November 15, 2006

Subject: Response to ACHCS Comments for Fuel Leak Case No. RO0000317: 5725 Thornhill Drive, Oakland, California 94611

Thank you for your letter dated August 15, 2006 in connection with the above addressed property. This letter addresses your technical comments as indicated in your letter. Your comments are bold and italicized and are followed by our response.

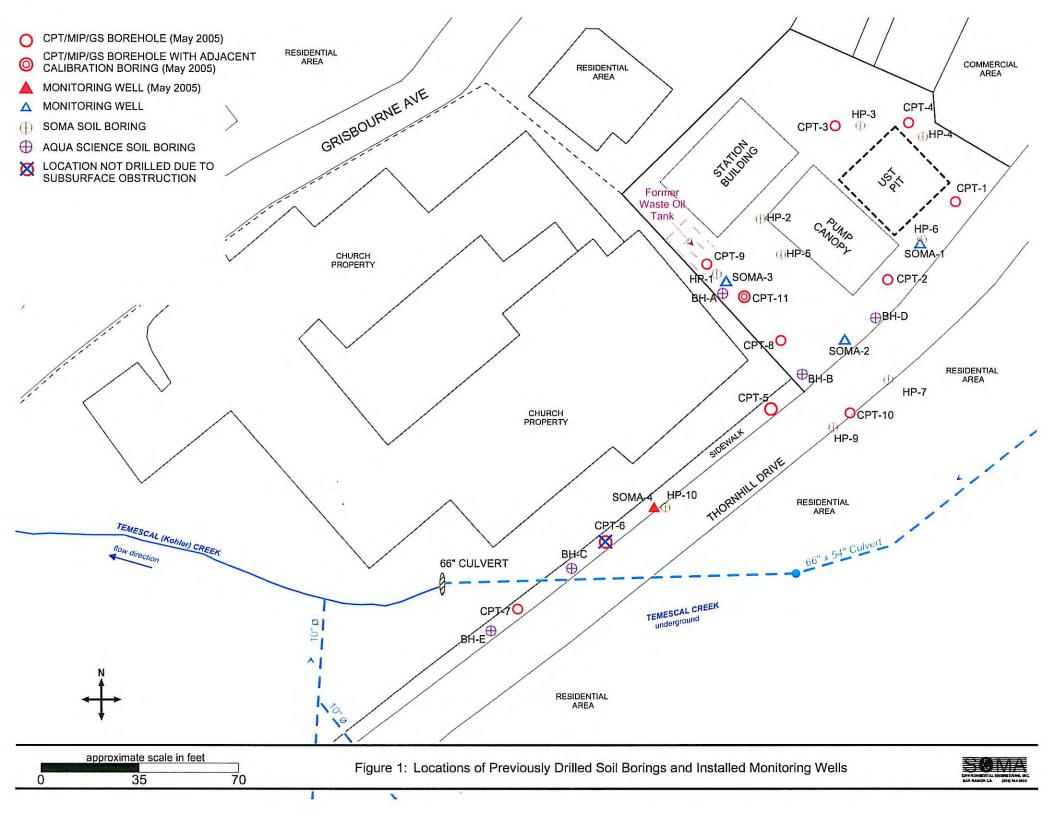
CPT-6 not installed- The proposed location is just upgradient from Temescal Creek and Boring BH-C sampled September 6, 2000, detected 25,000 ug/l TPH-Diesel, 7,300 ug/L TPH-Gasoline, and 5,300 ug/L MtBE. Nor was a soil borehole log provided. Please explain why "Previously planned CPT-6 could not be drilled due to physical constrains and obstruction of local traffic." Also, please include in a supplemental workplan, an alternative drilling method for this location or propose alternative boring locations.

The original "sidewalk" location of the CPT-6 boring was highly influenced by excessive traffic, and the presence of numerous utility lines, including a storm culvert running along the narrow Thornhill Drive, making it problematic to install the above boring in the street lane rather than in the sidewalk area. Figure 1 shows the original location of CPT-6.

During the advancement of the CPT-6 boring, an obstruction was encountered in the sidewalk area at a depth of approximately 3 to 4 feet bgs. Several attempts were made to advance the above referenced boring, approximately 10 feet to the west and to the east of the original boring location in the sidewalk area of Thornhill Drive. Each attempt was terminated upon encountering resistance at the similar depths. During this process the drilling equipment was damaged, and as a result, SOMA had to cease its efforts. SOMA exhausted its efforts and concluded that the encountered resistance could be construction debris, like

concrete fragments. An alternative drilling method and new boring location for the former proposed CPT-6 is outlined in our Workplan dated November 15, 2006.

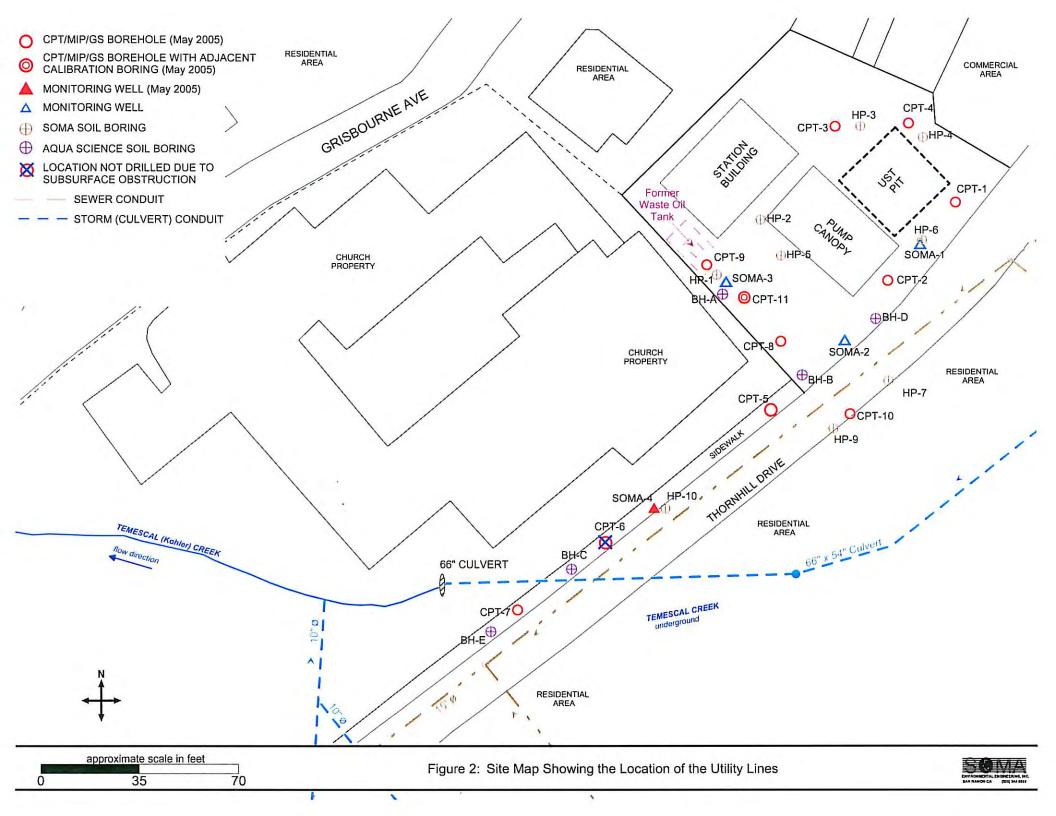
Cross-sections did not show contaminant data for soil nor groundwater samples, preferential pathways, the underground storage tank pit, and borings BH-A through BH-E- Please include in a supplemental workplan, a proposal to include contaminant data for soil and groundwater samples, preferential pathways, the underground storage tank pit, and borings BH-A - BH-E.

A new storm and sewer map, obtained from the City of Oakland Public Works Department, was used to plot the utility lines in close proximity to the site. Figure 2 shows the storm and sewer utility flow lines and their diameter and flow direction. Upon careful review of the new records it was concluded that the depth of utility lines next to the site ranges between approximately 9 to 10.5 feet bgs, and 14 to 15.5 feet bgs near the Temescal Creek culvert. Based on the fact that the approximate first encountered depth of the groundwater at the site ranges between 6 and 16 feet bgs, the existing utility lines can potentially act as a preferential flow pathway along Thornhill Drive.

Attachment A CPT/MIP Logs

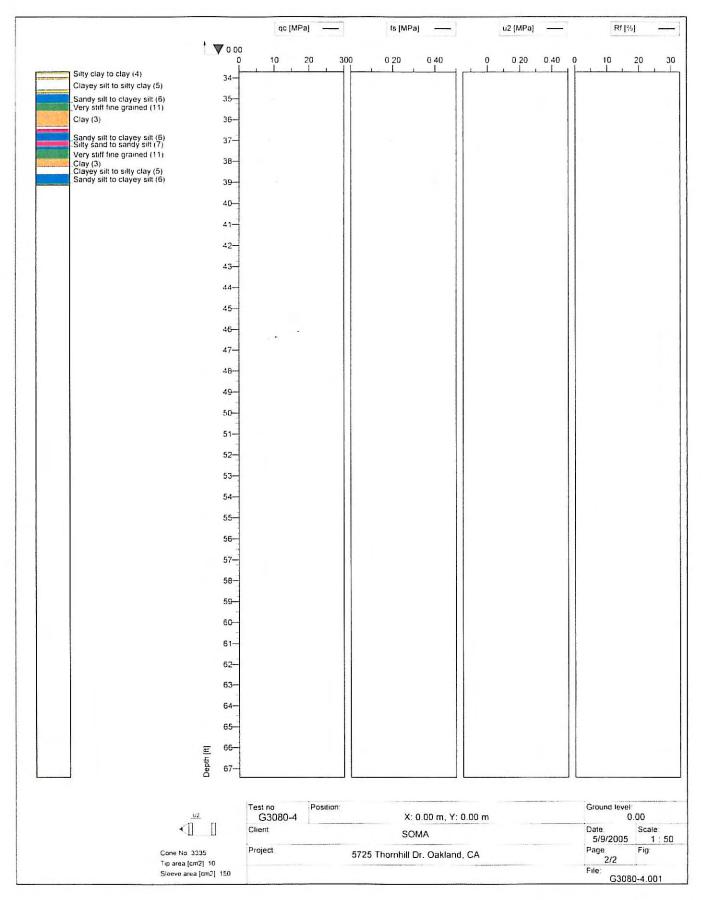
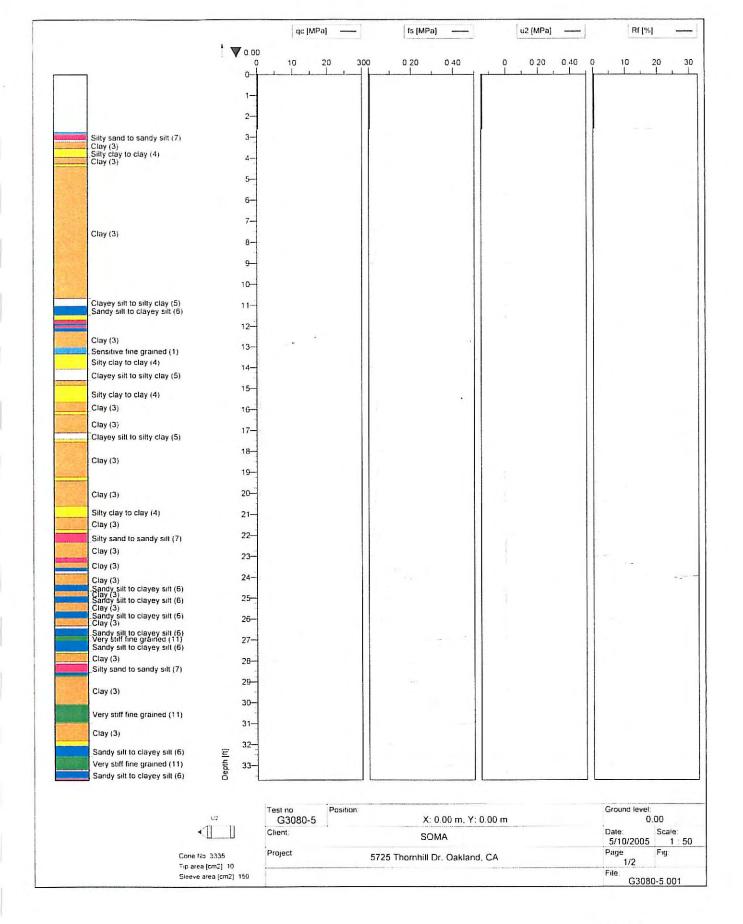
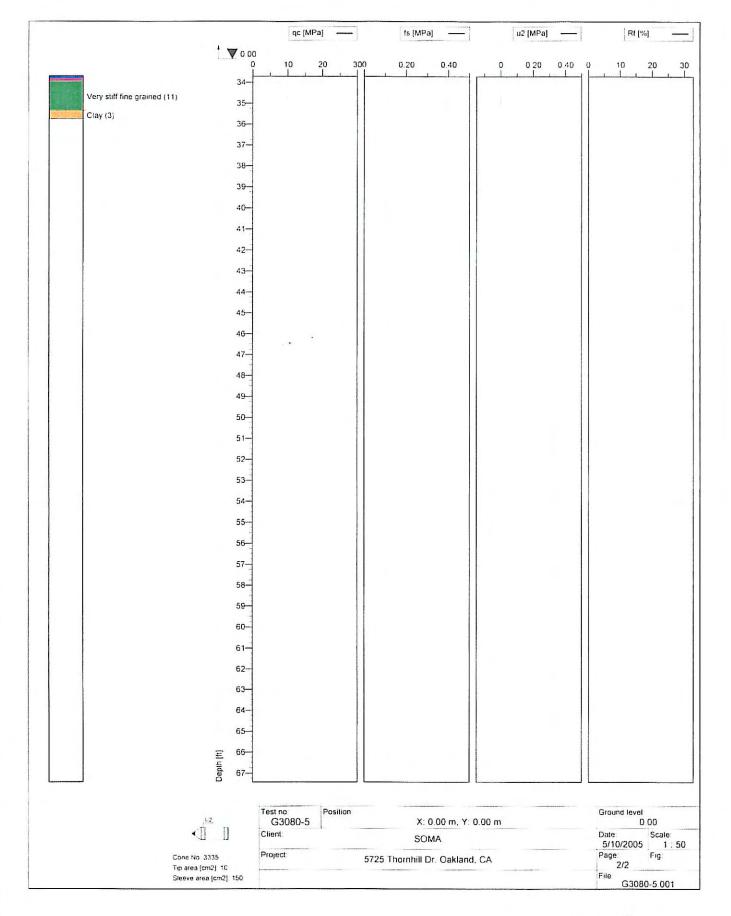
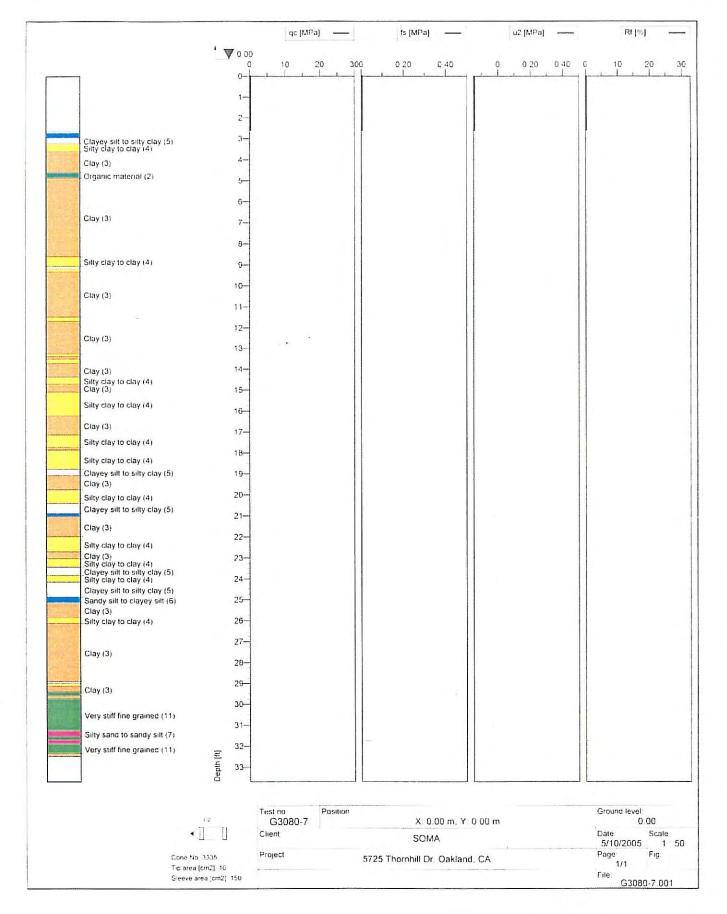
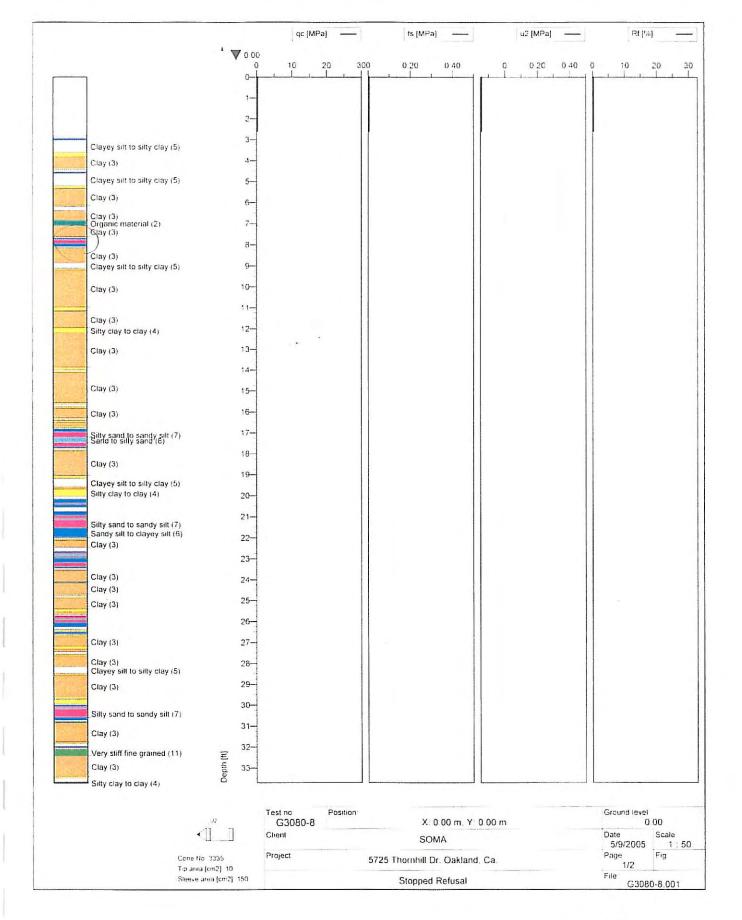
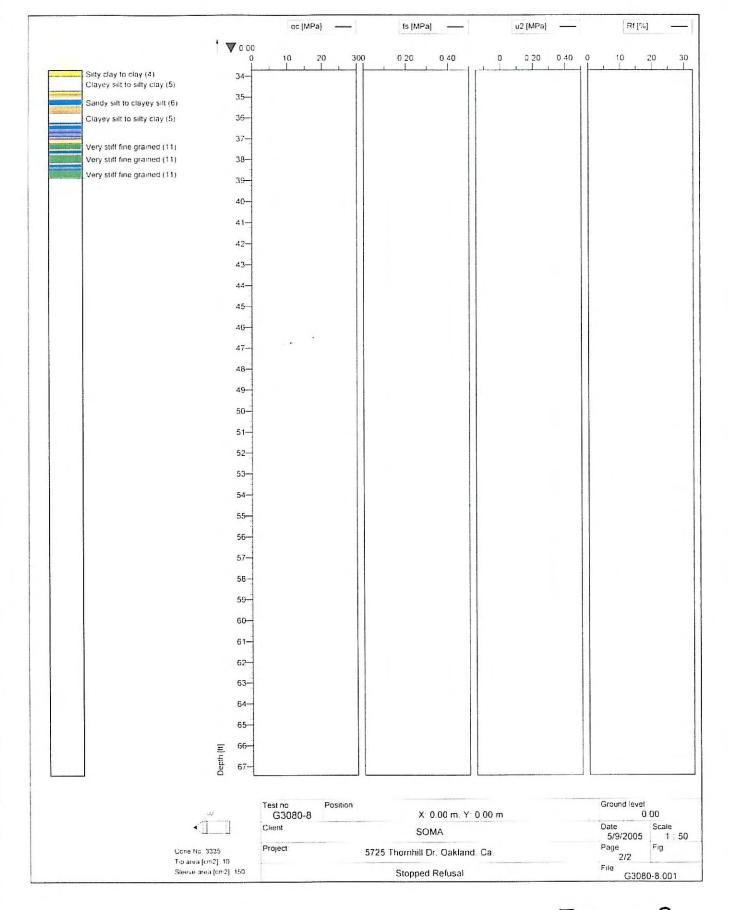
MIP charts did not identify the corresponding CPT/MIP borings- Please label MIP charts with their corresponding CPT/MIP boring number.

SOMA has complied with this directive. Properly labeled CPT/MIP logs are attached to this letter as Attachment A.
